CLARENCE CITY COUNCIL (PLANNING AUTHORITY) MEETING**MONDAY 17 DECEMBER 2018****TABLE OF CONTENTS**

3.1 DEVELOPMENT APPLICATION D-2018/96 - LAND AT THE JUNCTION OF TASMAN HIGHWAY, HOLYMAN AVENUE, KENNEDY DRIVE AND CRANSTON PARADE AND 51 CRANSTON PARADE - TASMAN HIGHWAY/HOBART INTERNATIONAL AIRPORT INTERCHANGE

Figure 1: Extent of intersection of Biodiversity Protection Area (BPA) and Waterway and Coastal Protection Code in relation to direct footprint of proposal and distribution of TASVEG units – note the area of ARS buffered by the Coastal and Waterways Protection Zone is also subject to E11

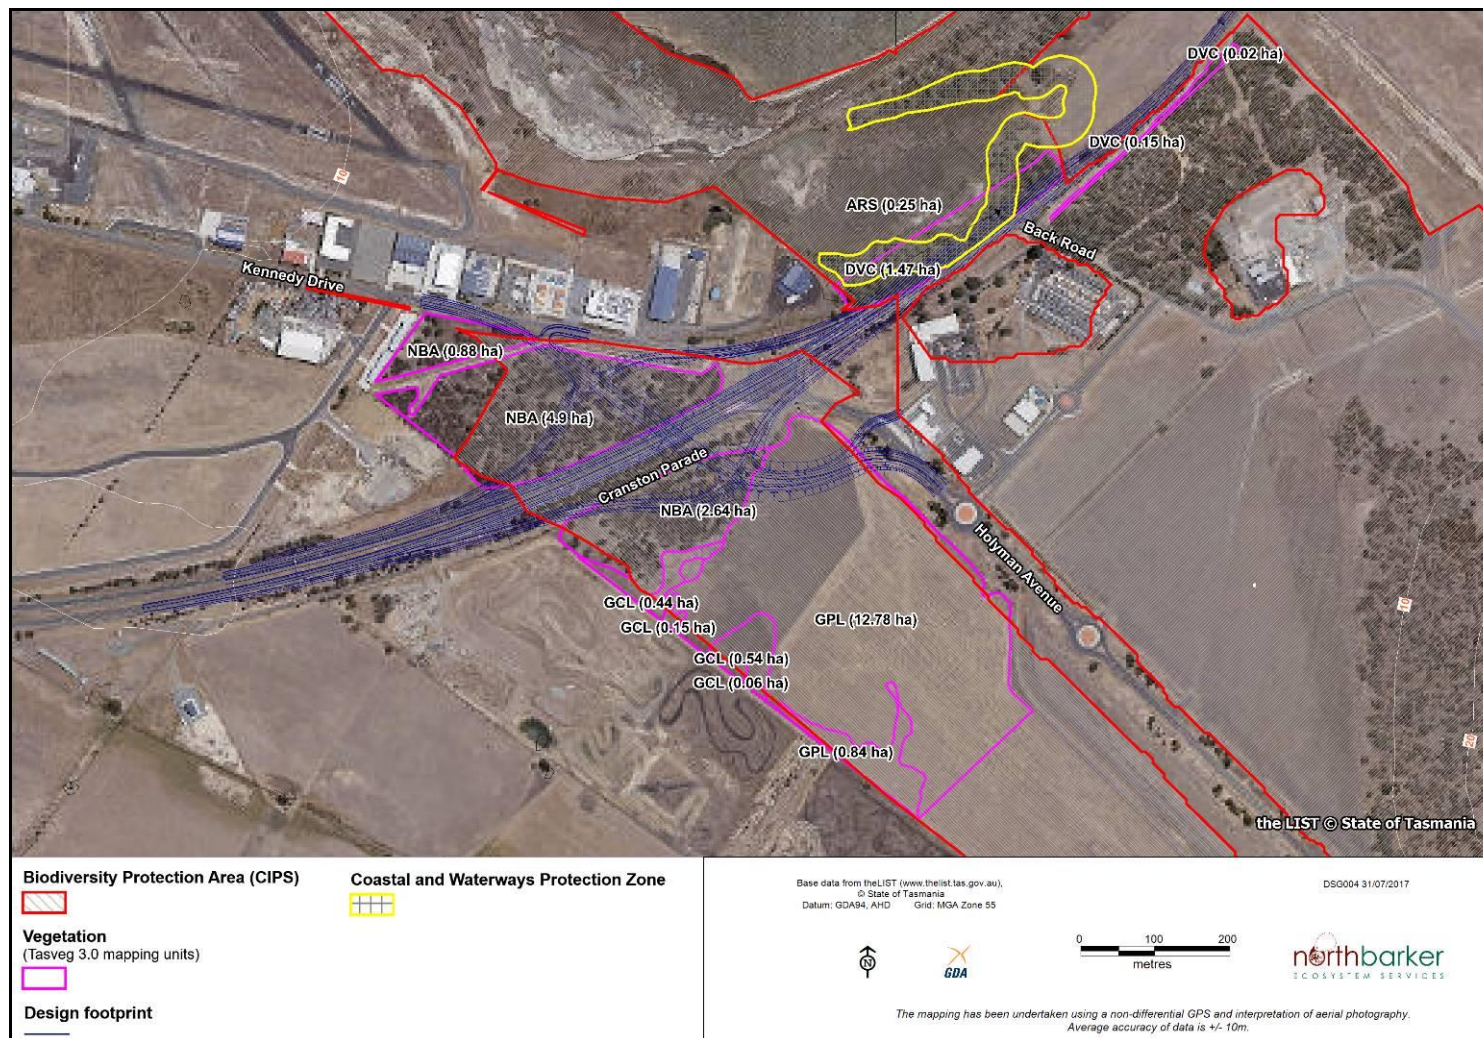
The proposal includes land within the area covered by the Biodiversity Protection Area (BPA) overlay and as such triggers a requirement to address the Natural Assets Code (E27) of CIPS (Figure 1¹).

All of the native vegetation within the area of the BPA specified in Figure 1 is classified as priority vegetation, with different patches qualifying in relation to some or all criteria. Our explanations of compliance with the requirements of the scheme focus on vegetation at the community level, as in this case that also covers the presence of species values within the patches, which include threatened flora and threatened fauna habitat.

Figure 2 - Expected impacts to EPBCA lowland grasslands of Tasmania

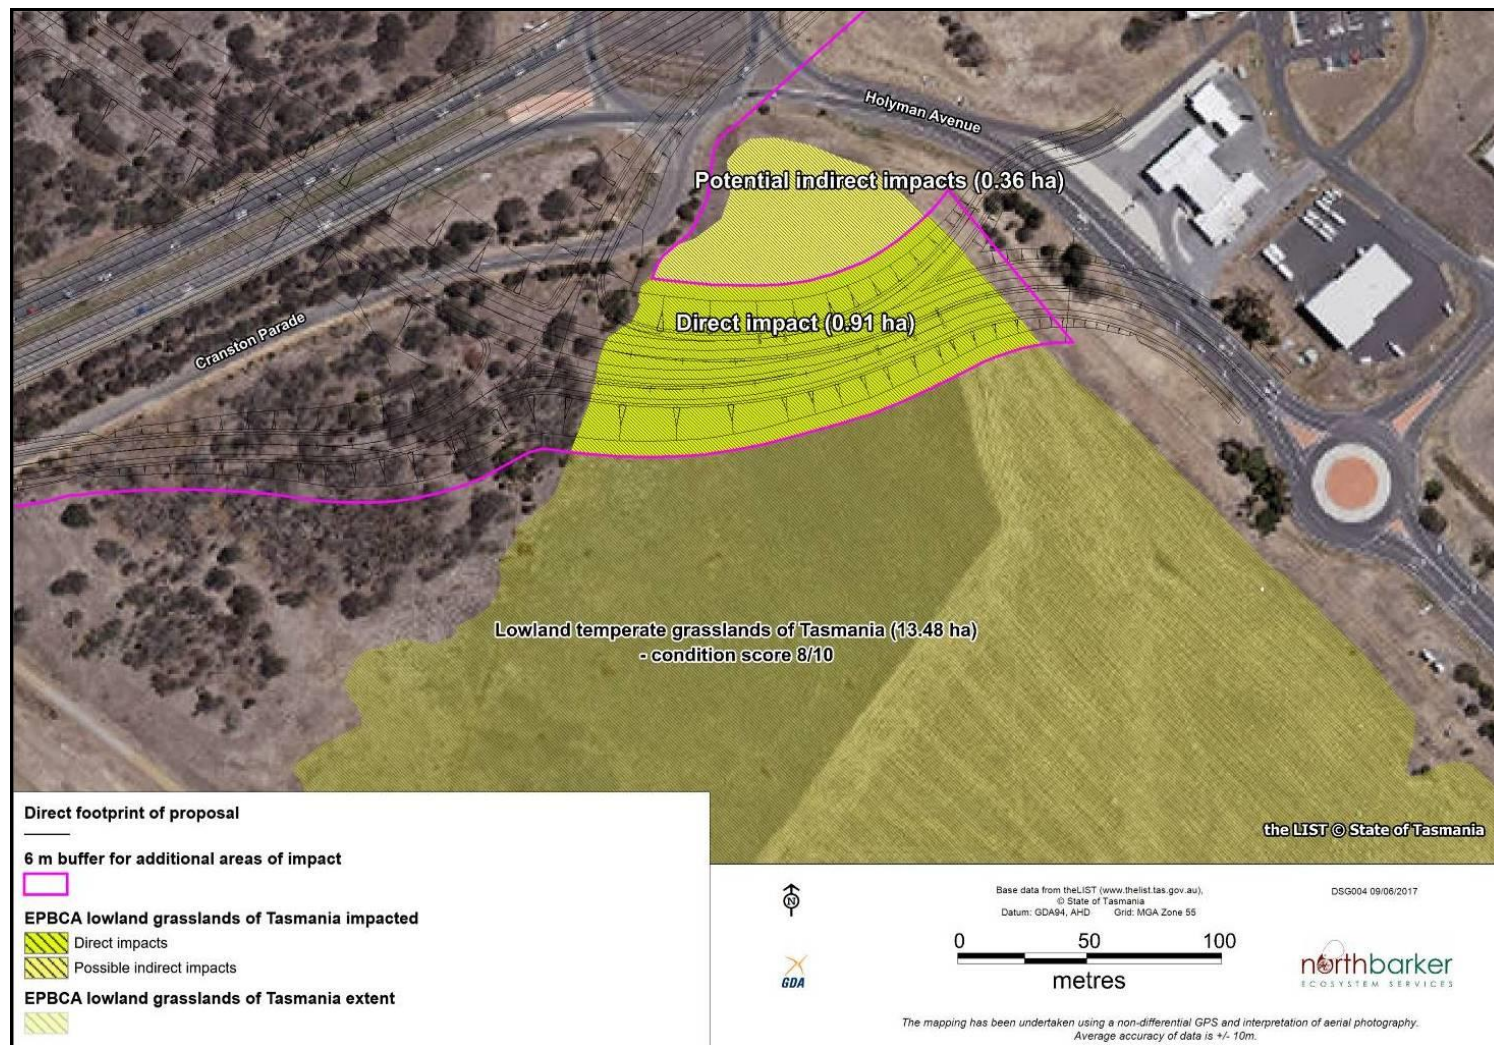
The condition of the offset vegetation is very good (Figure 2) and can be improved as part of achieving a net benefit.

This has been done and reported in Figure 2.
